This is to certify that T. Covington Johnson
has permission to Amend Permit #91091 window digger
AT 18 City Point Road, Peaks Island, ME

RE: 18 City Point Road, Peaks Island, - 087-S-009 - IR-2 Zone

I have reviewed your most recent amendment to your building permit. As you remember this amendment was requested because you again did not follow your submitted plans. The approved window in the upper loft area facing the ocean was changed to a sliding door that exits out on to a roof at this time. You claim that this door is actually a window. You also claimed that there is no difference between a door and a window.

outside view

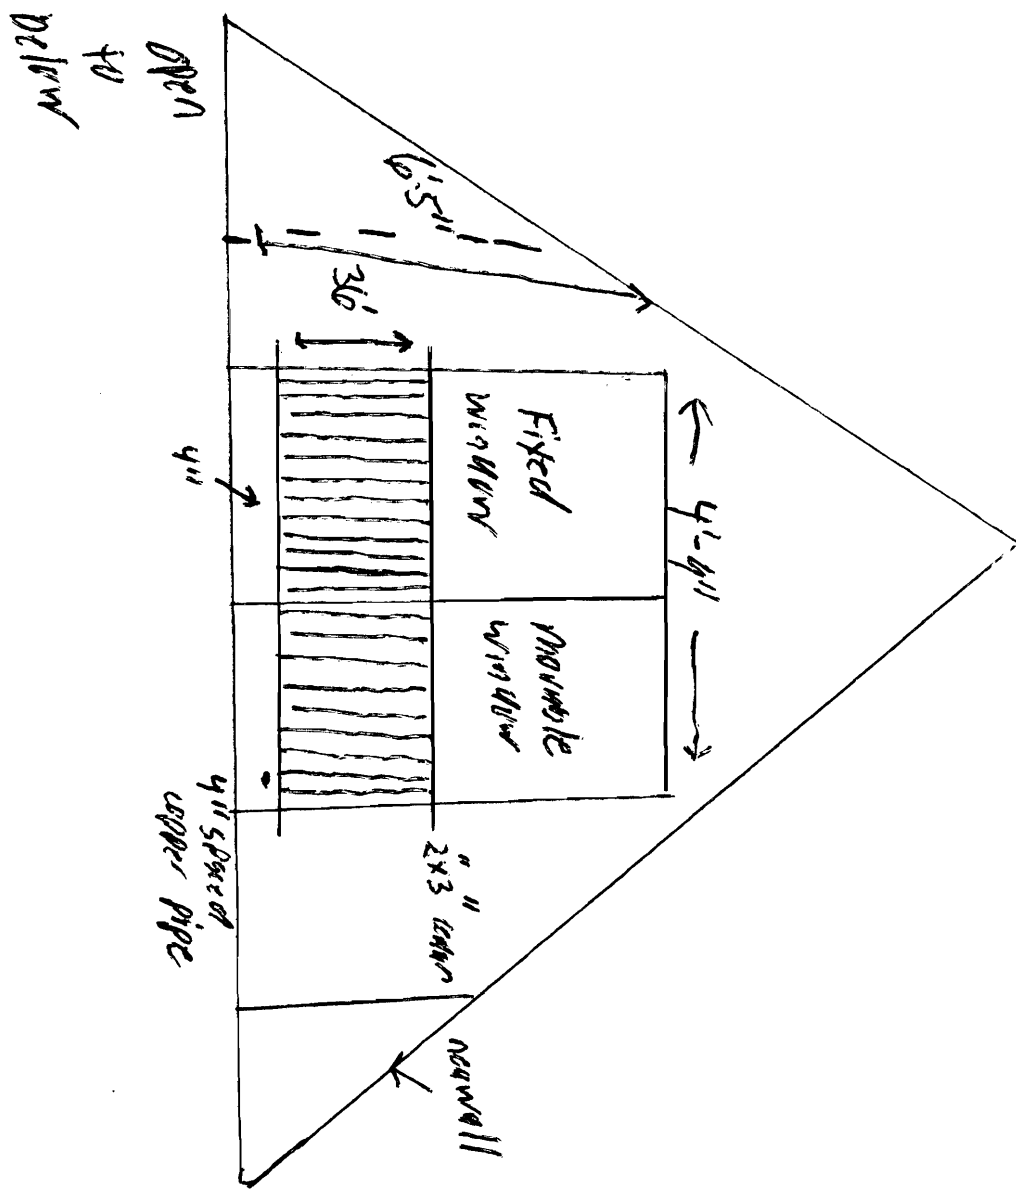
There is a difference between a door and a window. Their uses are self explanatory. A door is used for entering and exiting. A window is for light and air. Because you are in a shoreland overlay zone, the difference between a door and a window is even more significant. In your particular case, you are at the maximum floor area allowed for increase. The installation of a door is inviting the occupant to go out onto the roof which conveniently has protections on either side of the roof (which was only approved as a pitched roof without side protections). I realize that you are now calling this door a window, but I do not think that changes the function of the sliding door, nor changes the reality of what it actually is. I also understand that you are proposing to install balusters on both sides of the door to prevent its use. I still would not allow that door because it gives tacit approval to its real function of a door. And it is my opinion that the balusters will not last long. The area is set up for use as an outside deck. The City will not be put in the position of encouraging the misuse of a roof/deck to be used in excess of the shoreland zoning provisions.

Therefore, I am denying this amendment for the door and the balusters as you have submitted. It will be necessary to adhere to the original approval for a window. Please note that I realize that people can open a window and climb out of it to go on the roof. But it takes much more effort to do so. It will be your responsibility as owner not to allow that action, because as I have stated several times previously, the roof shall not be used as a deck or any alternate use other than a roof.

As long as the door is in place, this office will not grant a temporary or permanent occupancy permit.
